NOTICE OF DECISION

DECISION OF THE HEARINGS OFFICER

**CONDITIONAL USE / CLASS 3 SITE PLAN REVIEW / CLASS 2 DRIVEWAY
APPROACH PERMIT CASE NO.: CU-SPR-DAP18-05**

SUMMARY: A conditional use and site plan review and driveway approach permit application for building additions, removal of a driveway, modification of a driveway, and reconfiguration of parking areas for a religious assembly.

1 SITE PLAN

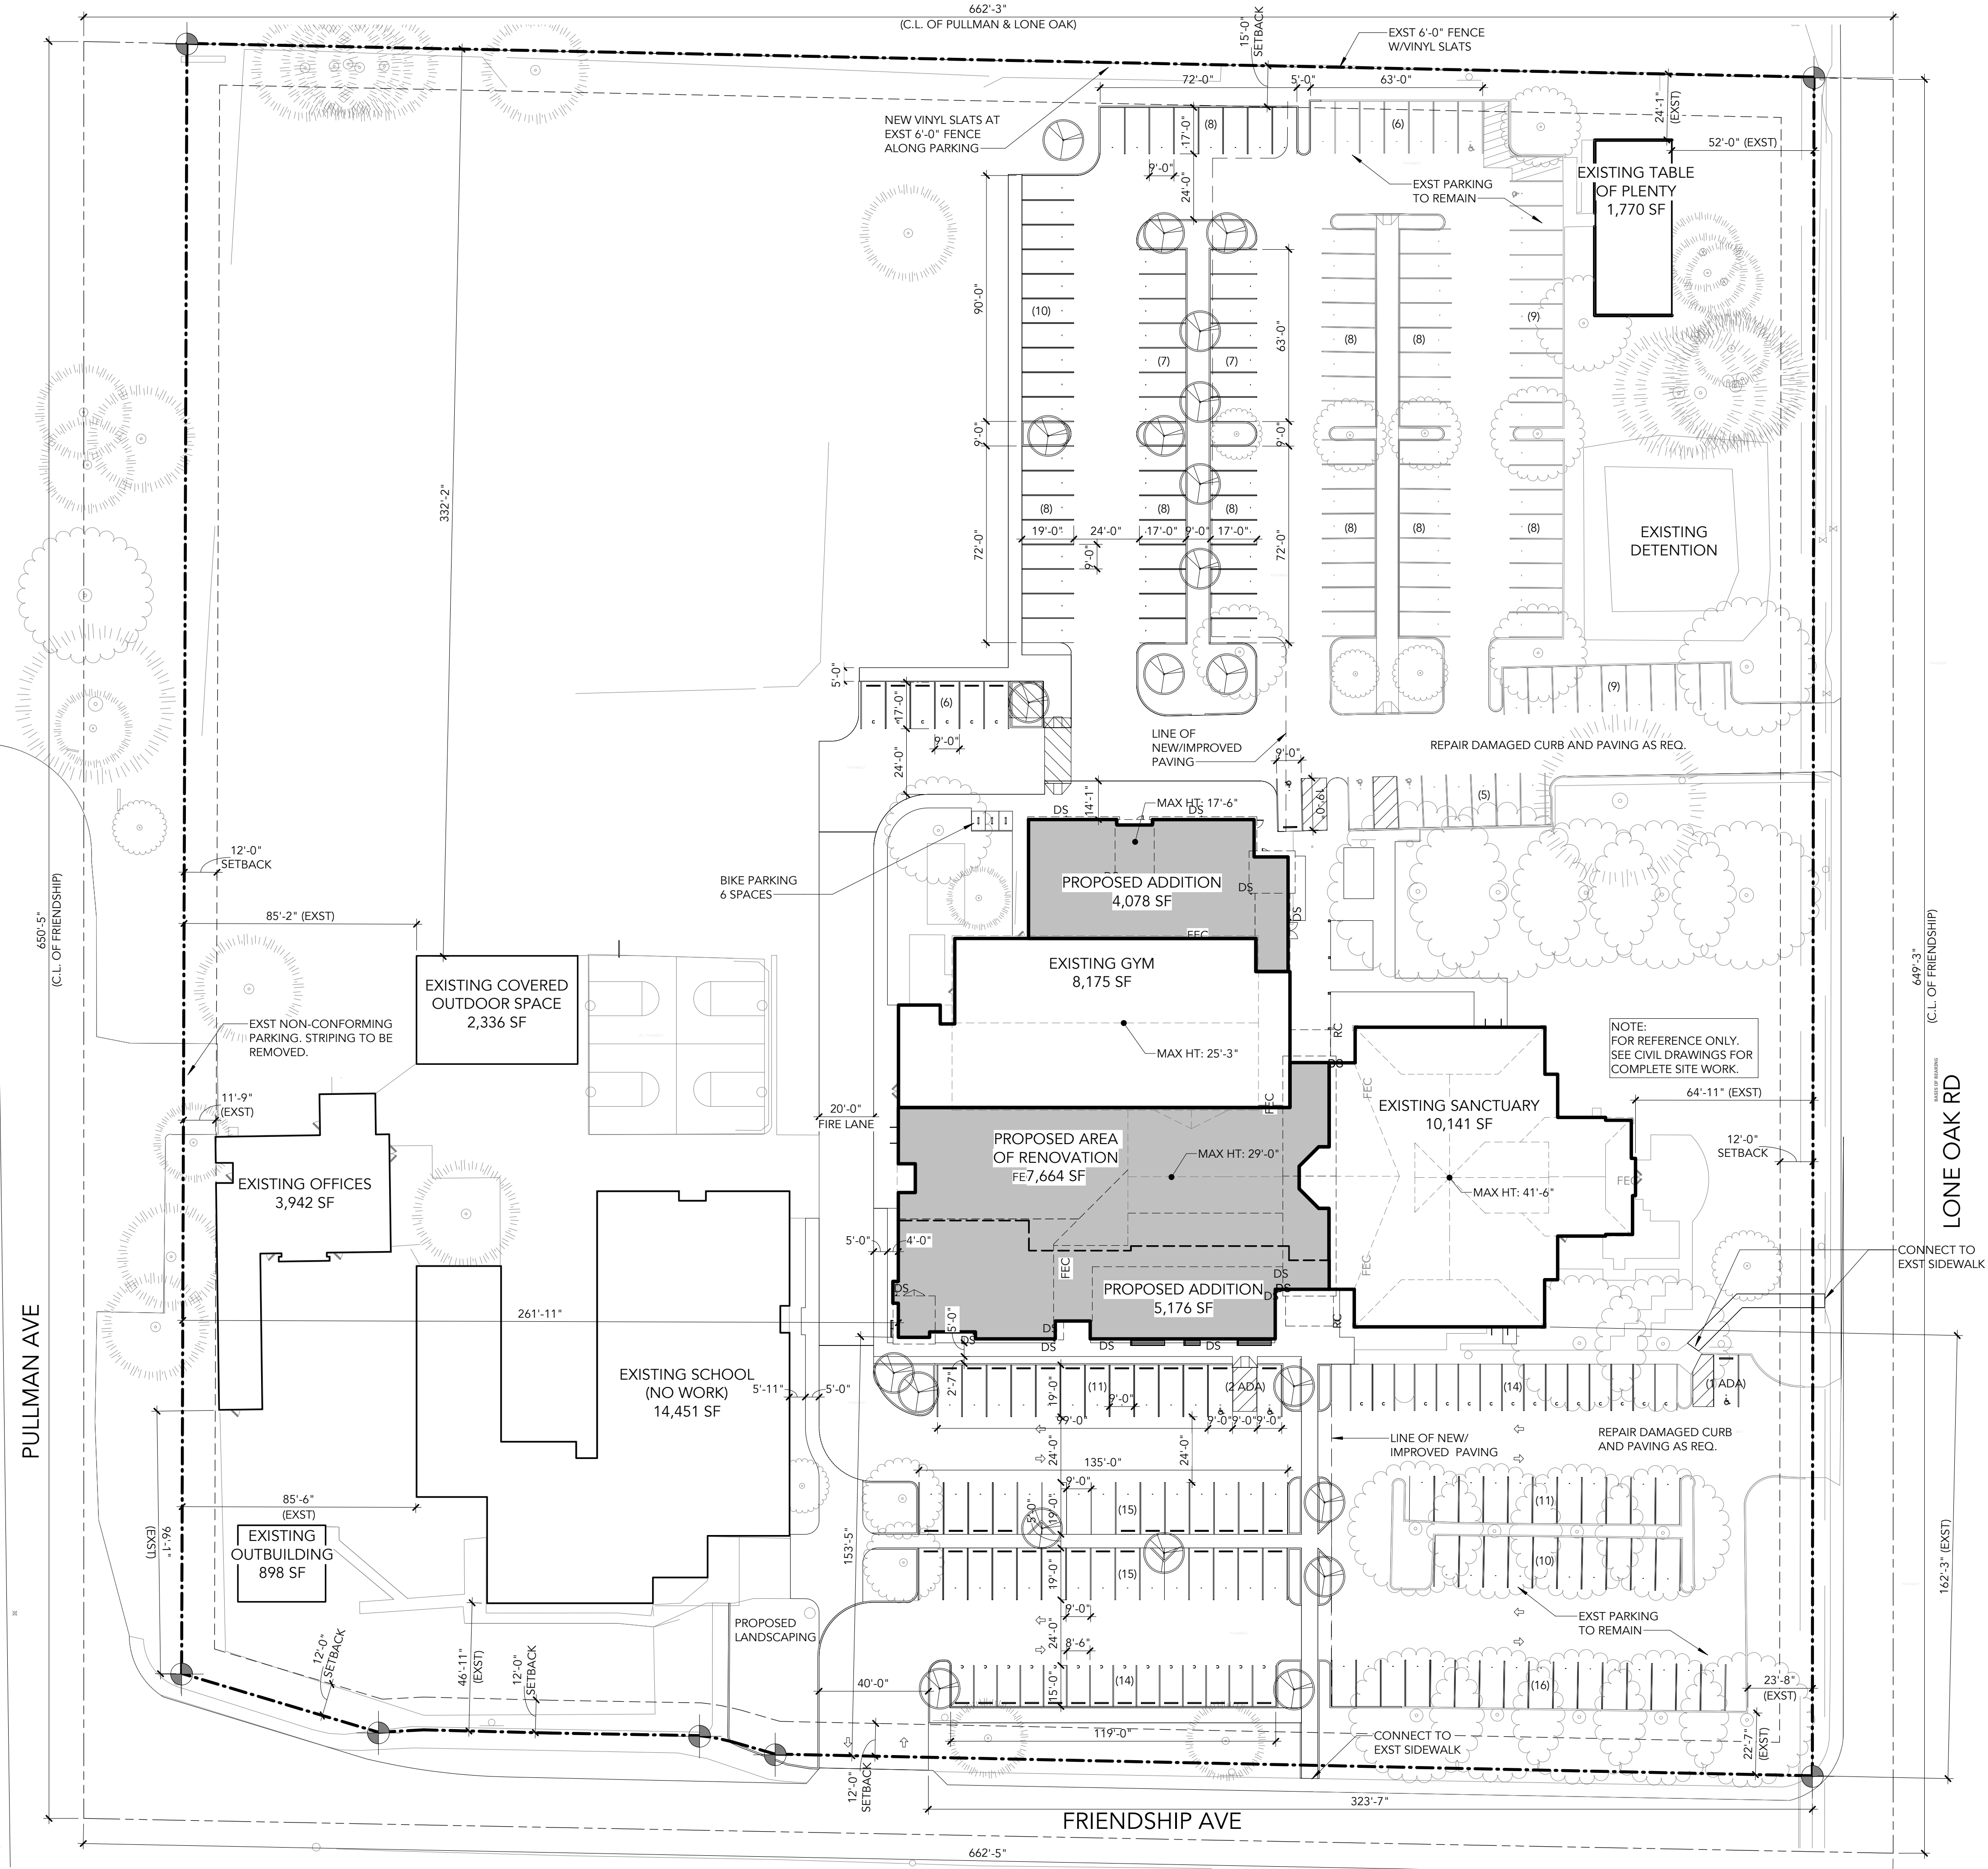
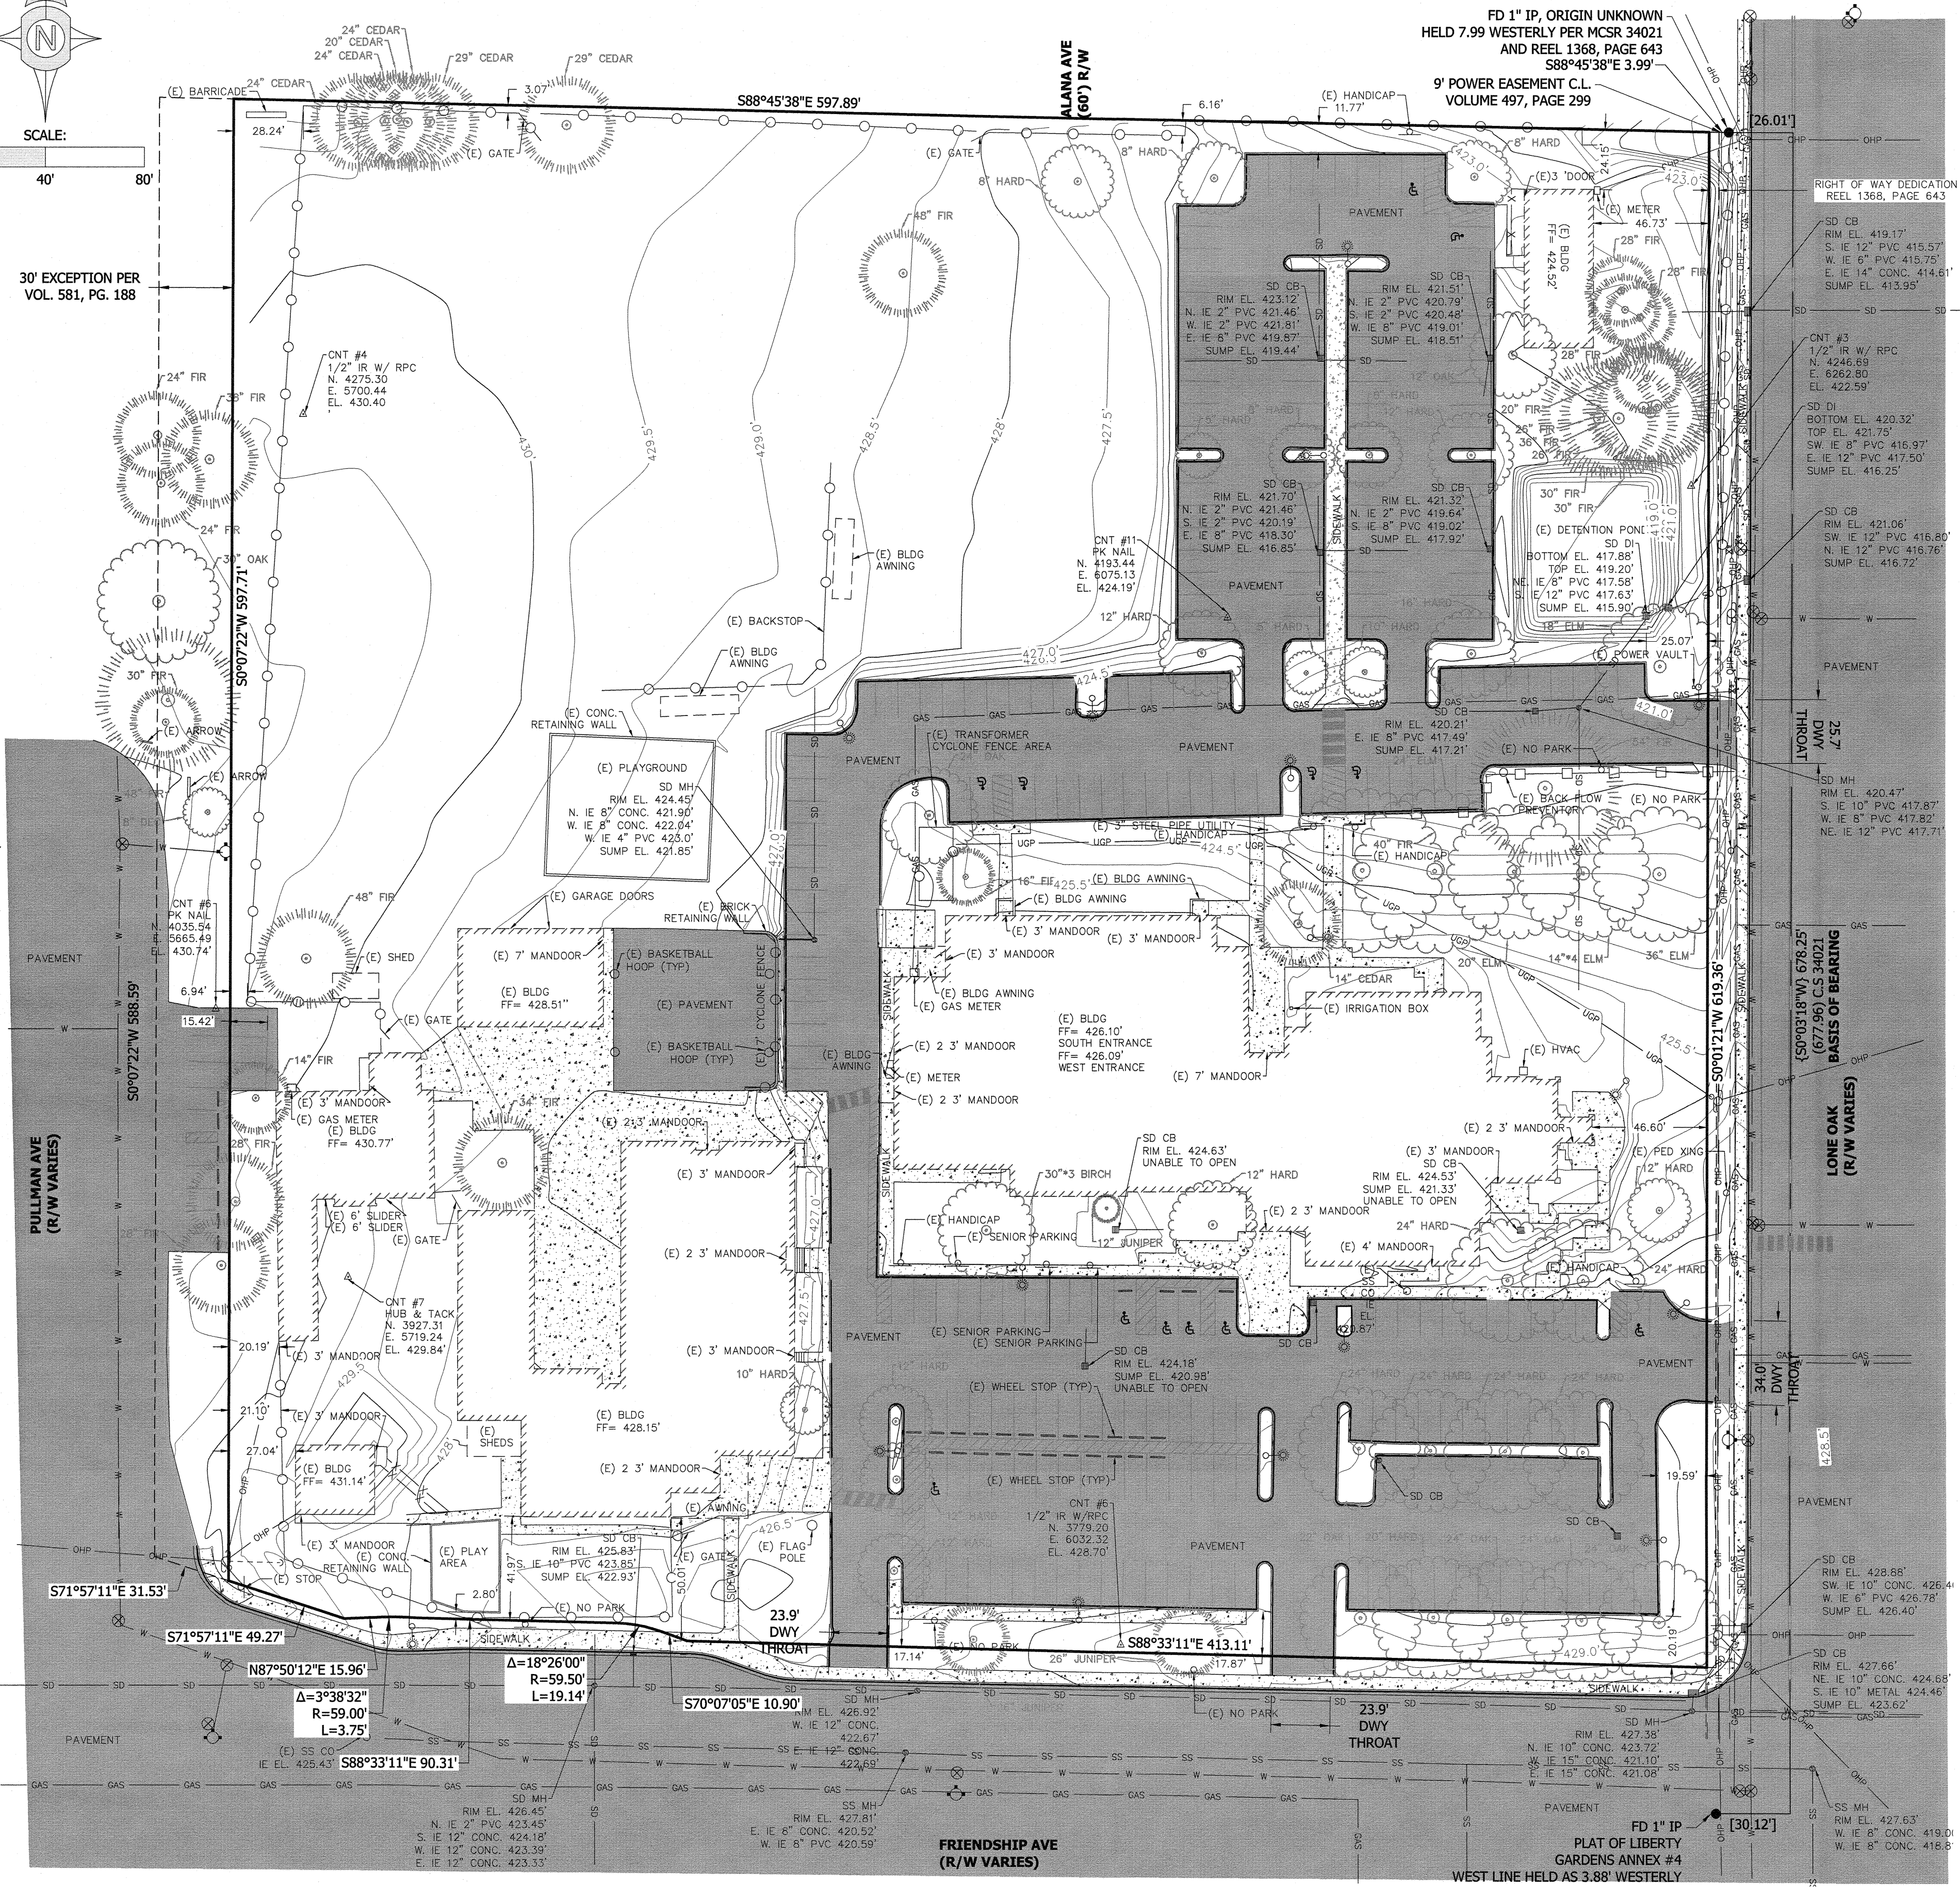
It appears fire department access is being addressed, but Fire was not able to verify turn radii. Fire department access and water supply will be required. Items including these will be addressed at time of building permit plan review.

Fire department access is required to be provided to within 150 feet of all portions of the structure. Fire department access is required to be a minimum of 20 feet wide and 13-6 feet clearance in height. Turn radius are 28 feet inside and 48 feet outside. Fire will need verification of these dimensions (turn radii on the north and south ends of the fire lane shown on the west side of the project).

The Hearings Officer notes that the proposed site plan shows the north parking area, including existing and reconfigured areas, to be approximately 49,900 square feet with 136 spaces and the reconfigured south parking area to be approximately 40,000 square feet with 110 spaces. The minimum interior landscaping required in the reconfigured and expanded north parking lot is 2,495 square feet, including 11 trees. The minimum interior landscaping required in the reconfigured south parking lot is 2,000 square feet, including 9 trees. The proposed landscaping exceeds the minimum requirements. However, two of the proposed triangular tree wells in the reconfigured south parking lot are smaller than 25 square feet and also would prevent the adjacent parking spaces from meeting dimensional standards. These triangular planting areas are not required to meet the minimum interior landscaping standards. The Hearing Officer imposes the following condition to ensure that the parking spaces meet dimensional standards:

The Hearings Officer finds that the reconfigured section of the southern parking area with new/improved paving and the expanded area of the northern parking area are subject to these standards for grade, surfacing, drainage, bumper guards or wheel barriers, parking area striping, marking and signage for one-way traffic and compact parking spaces, and lighting. The northern parking area is subject to screening from the abutting residentially zoned property. Bumper guards or wheel barriers are required so that vehicles do not overhang into required setbacks or pedestrian walkways. The site plan does not depict bumper guards or wheel barriers in all areas where they should be located. Accordingly, the Hearings Officer imposes the following condition:

Condition 2: Provide a landscaped setback of at least 15 feet between the new parking lot pavement and the north property line, landscaped with a minimum of one plant unit per 20 square feet and screened with a minimum 6-foot-tall sight-obscuring fence, wall, or hedge.

Condition 3: Remove the proposed triangular planting areas in the reconfigured south parking lot.

Condition 4: The eight new parking spaces in the northern row of the expanded north parking lot shall be designated as compact spaces.

Condition 5: The 20-foot-wide "Fire Lane" depicted on the site plan between the north and south parking areas shall either be widened to a minimum of 22 feet to accommodate two-way traffic or designated and marked for one-way traffic.

Condition 6: Bumper guards or wheel barriers shall be installed in the eight new parking spaces in the northern row of the expanded parking lot and all of the parking spaces abutting the proposed sidewalk that is oriented east to west through the reconfigured area of the southern parking lot.
